May 12, 2024

To Eversource and the PAC,

in the summer of 2023 I asked Eversource for profile drawings of the proposed X-178 line/structures on my property. Through its project representative, Eversource stated that it did not provide these profiles, though it of course has them for the whole X-178 line. Below is an example from the O-154:

Conductor Performance Map, 1.108" OD, 800-ft RS, NESC "Medium", NESC Limits

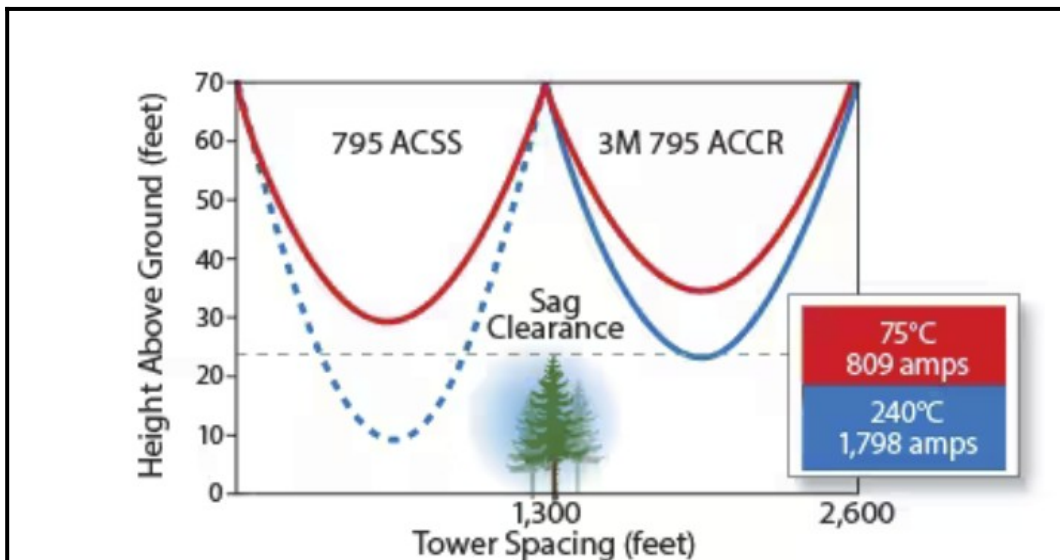
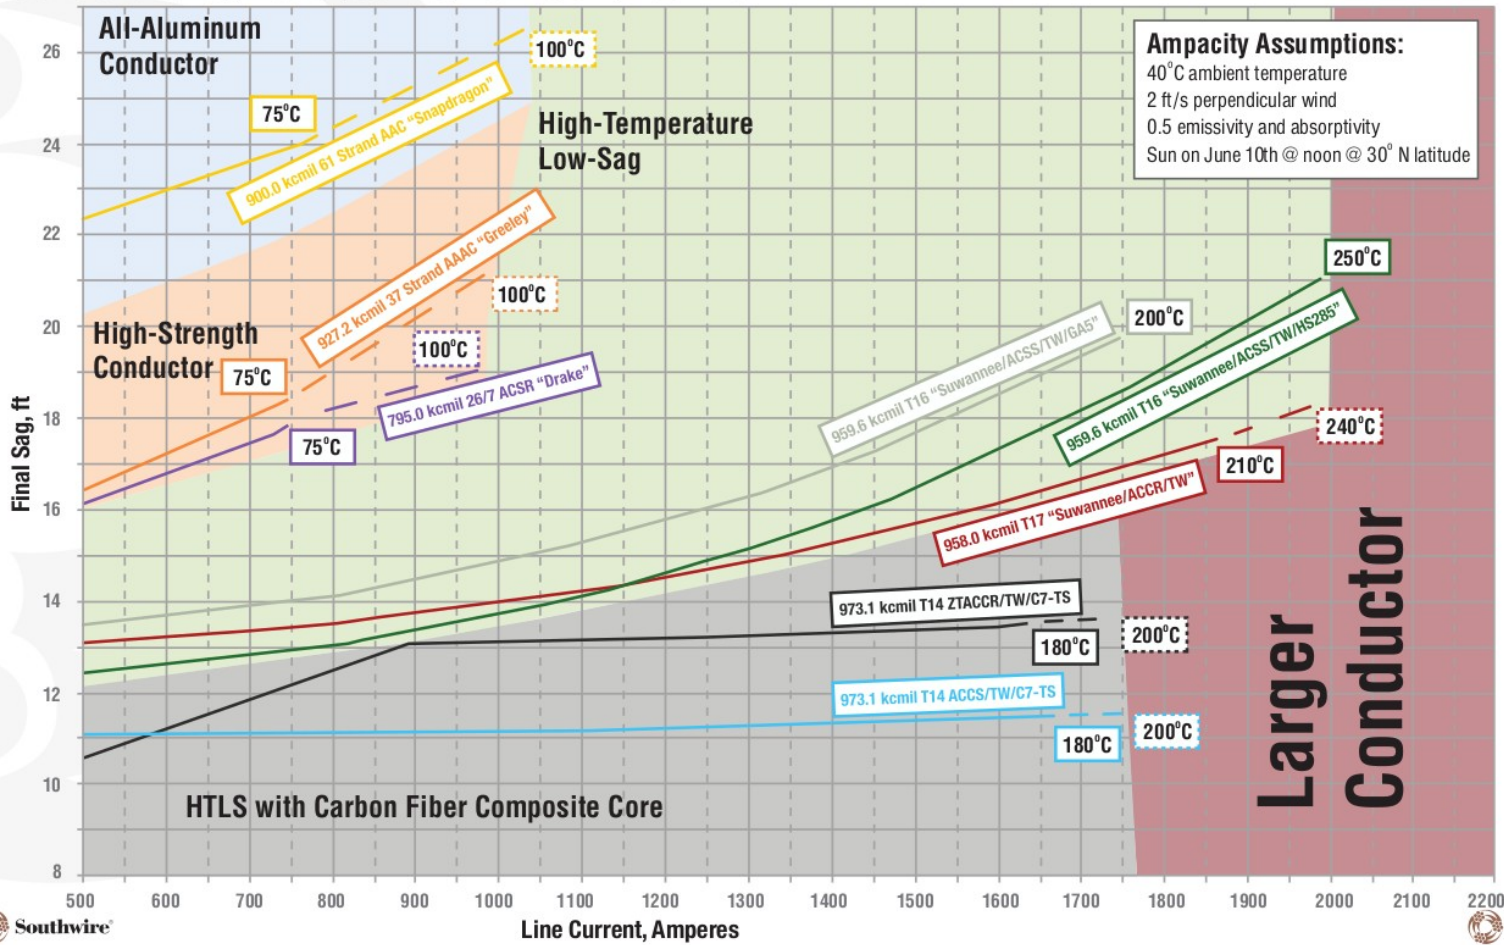
If Eversource used 973.1 T14 ACCS/TW/C7-TS conductor, which would carry 1819 amps, structures could be almost 20' lower (12' sag vs. 32' sag for 1272 ACSS), in an 800' span.

**Lower weight reduces sag**

A lighter weight, high temp low sag conductor (HTLS) with twice the ampacity (or more), 3M ACCR doesn't place extra weight or force on towers while meeting mechanical and clearance requirements. It carries more power in the same size cable and can run at higher temperatures without additional power line sag.

Below: "Portion of structure that will increase in height"

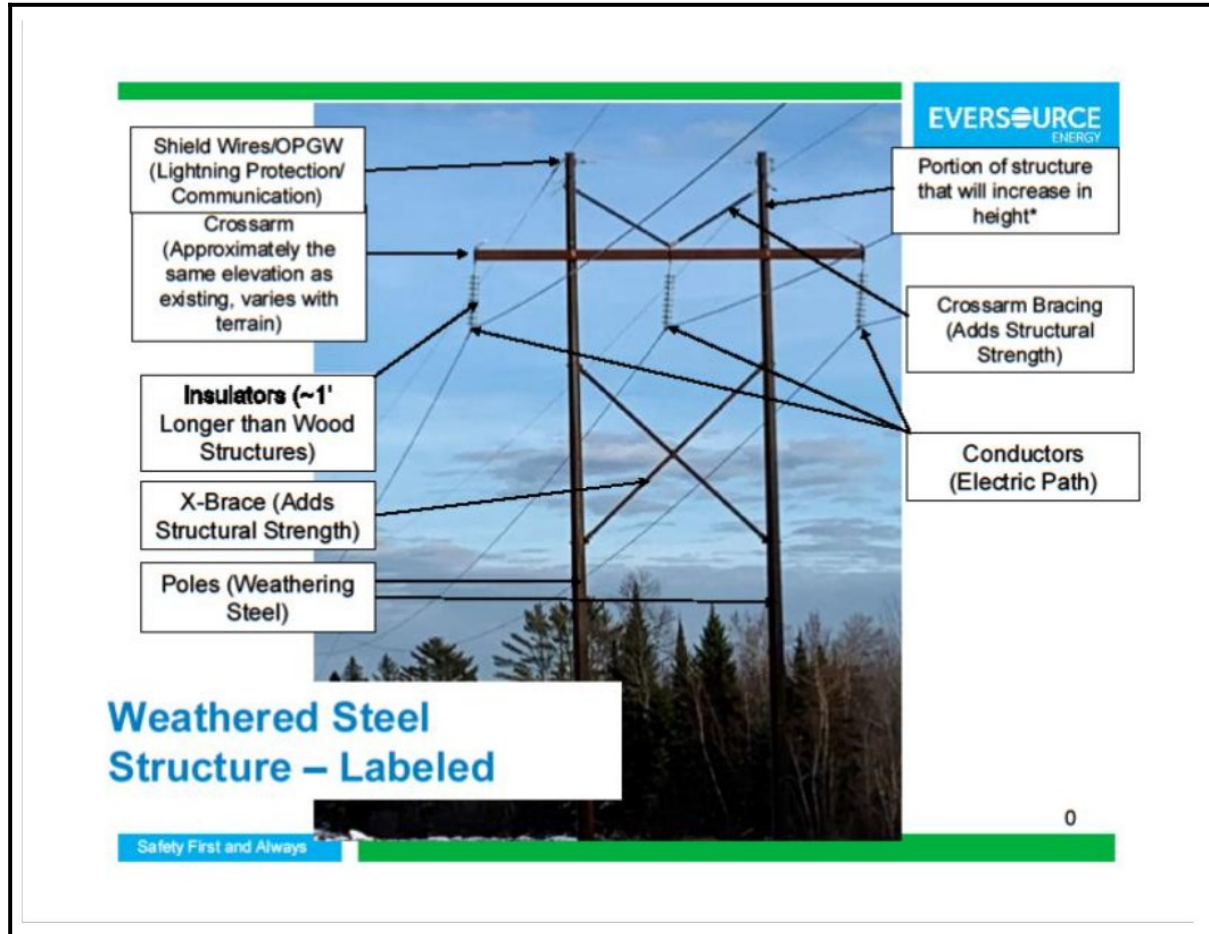
Add to this Eversource's claim that the height increases in it's rebuild are because of a need for increased clearance between the OPGW and the conductor:

Eversource continues to pretend that the the alternatives of replacing only the 41 Category C poles in 5-10 years, and re-conductoring the existing structures with ACCC type conductor, do not need to be addressed.
